**Planning Department  
Transportation Development Services**

**Re: Applebee's- Montañó Plaza, 6200 Coors Blvd.  
Submittal for Certificate of Occupancy – Transportation Development**  
Engineer's Stamp dated 05-19-14 (E12-D003A)  
Certification dated 11-03-14

The Letter of Certification submitted on 11-10-14 is not sufficient for acceptance by this office for final Certificate of Occupancy (C.O.). The following items need to be addressed:

professional seal  
site plan for building permit  
cp-102

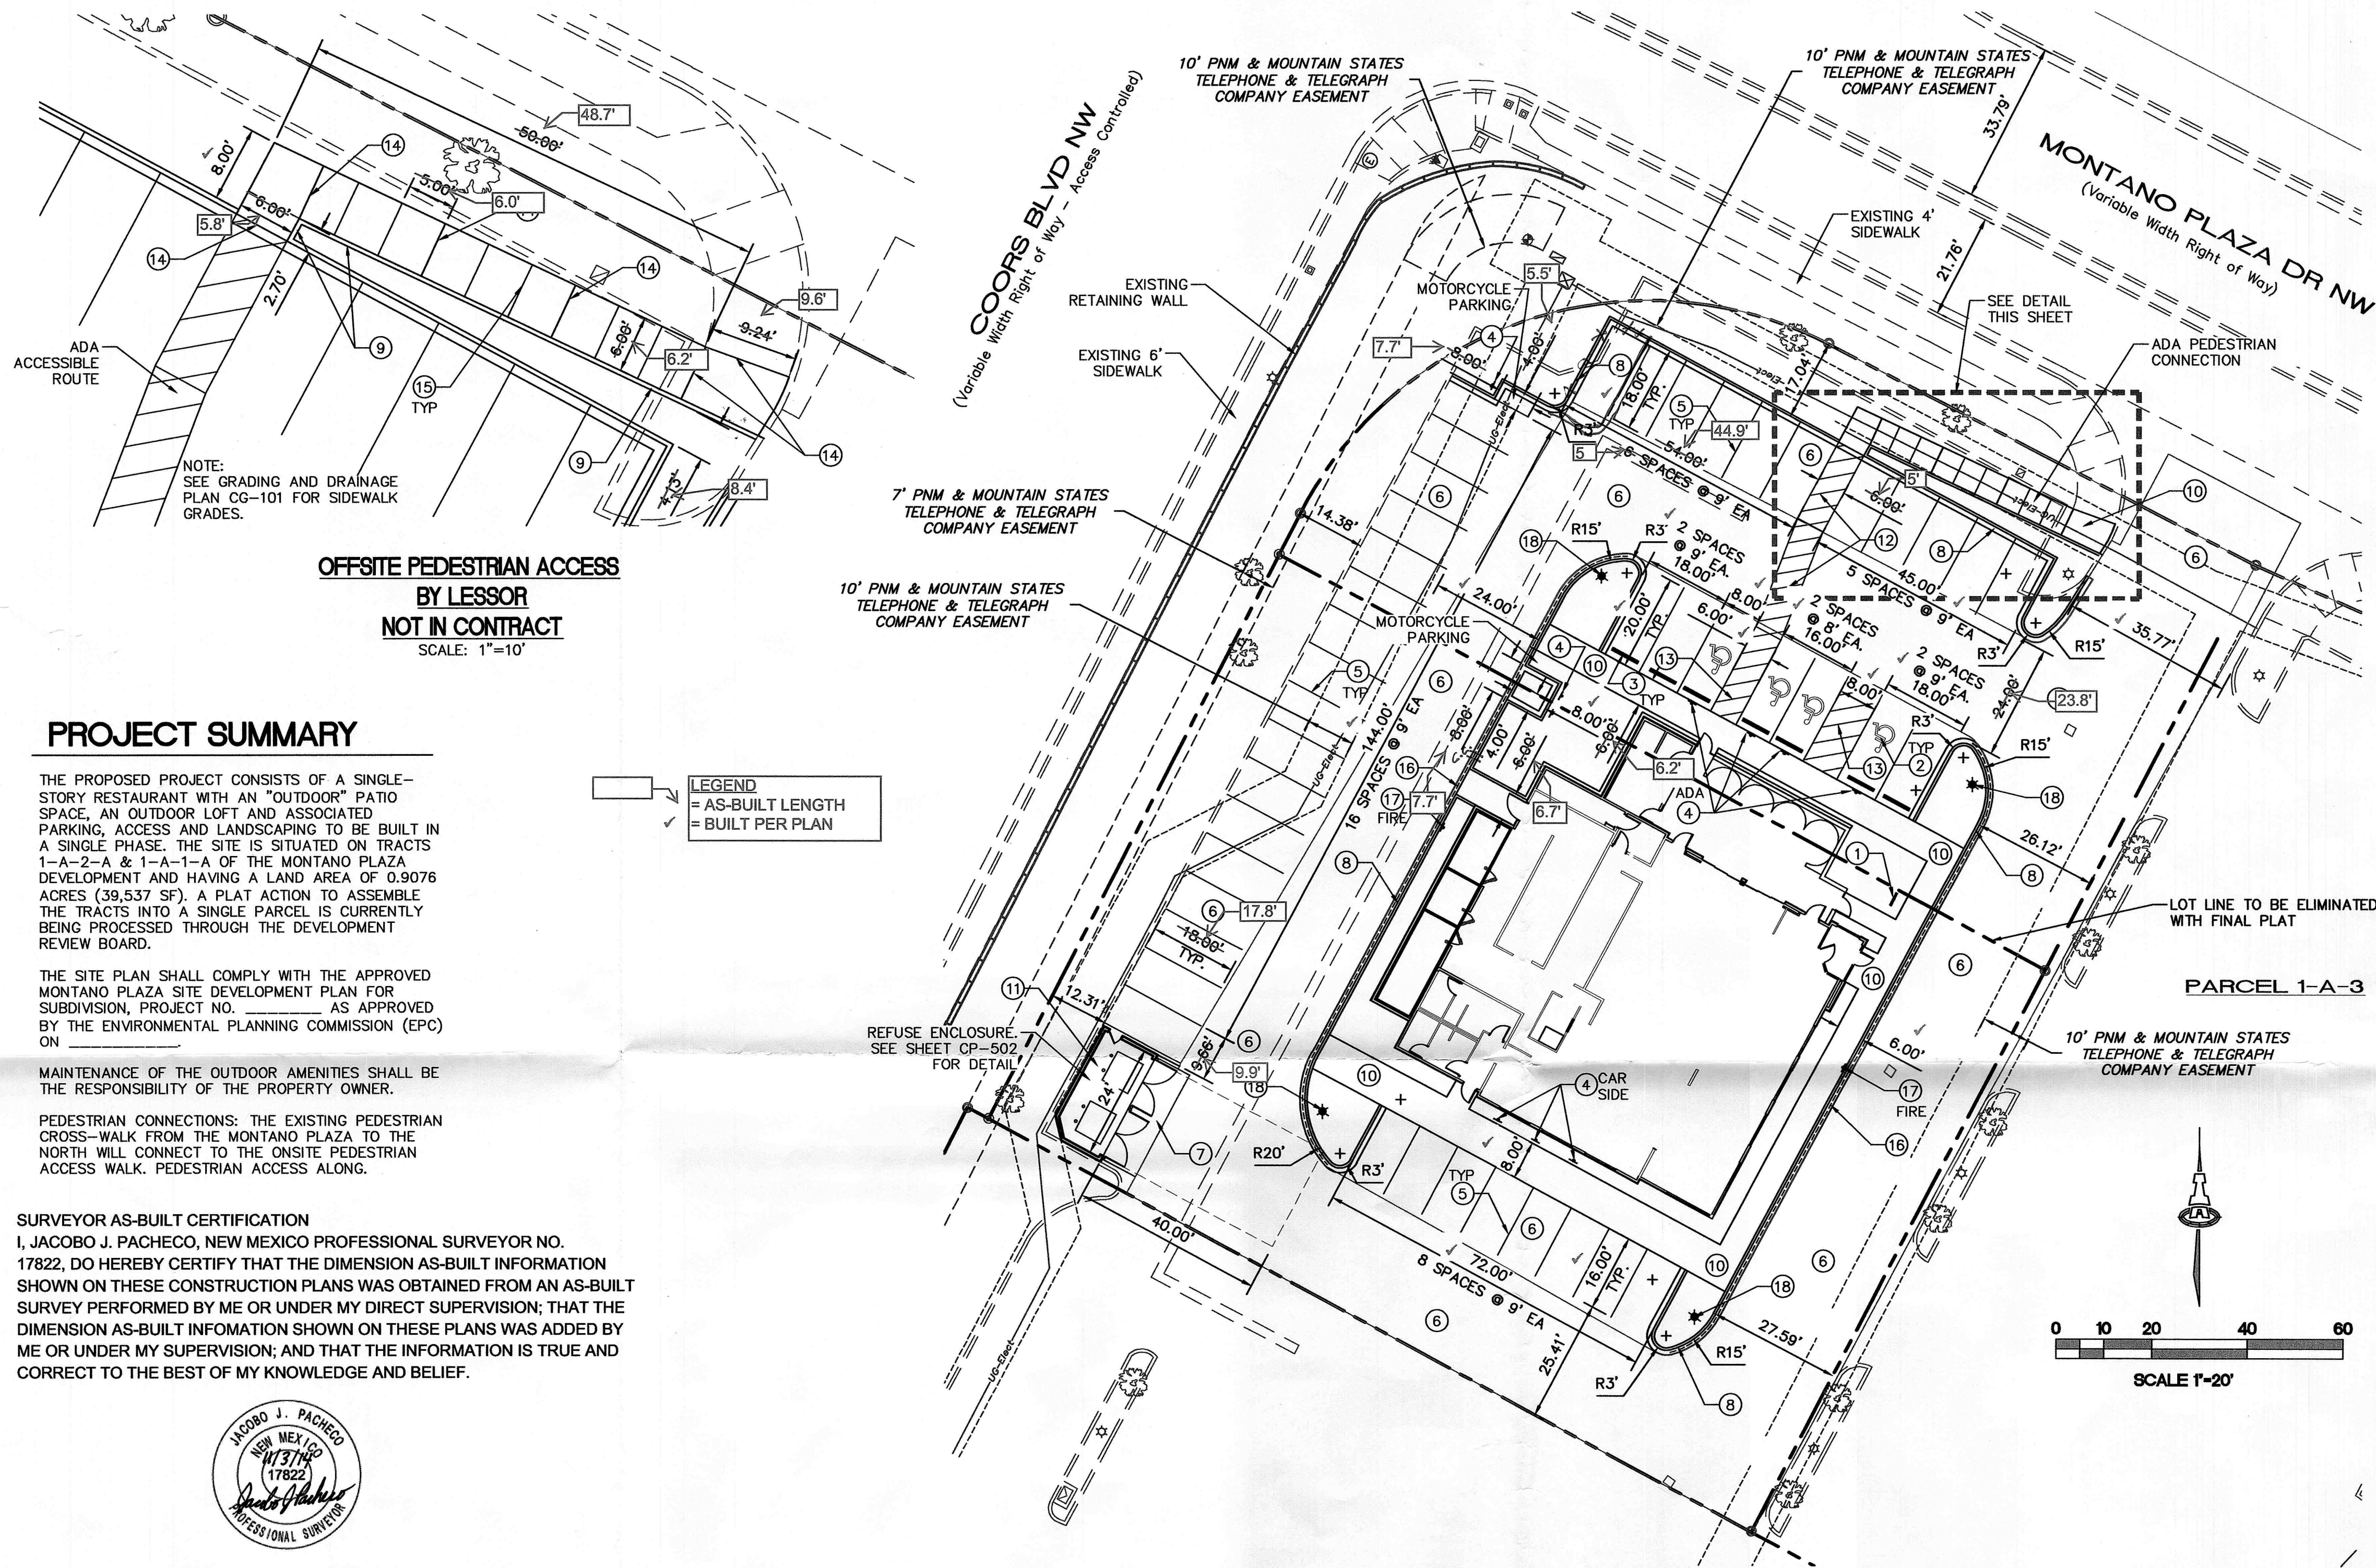
- The DRB Site Plan (or most recent AA) submitted for Final C.O. needs to be the latest edition, which may have redlined comments, initialed and dated by the designer-of-record.
- Engineer's Certification language needs to certify the transportation improvements rather than the hydrology improvements.
- The site needs to be cleared of construction materials and equipment.
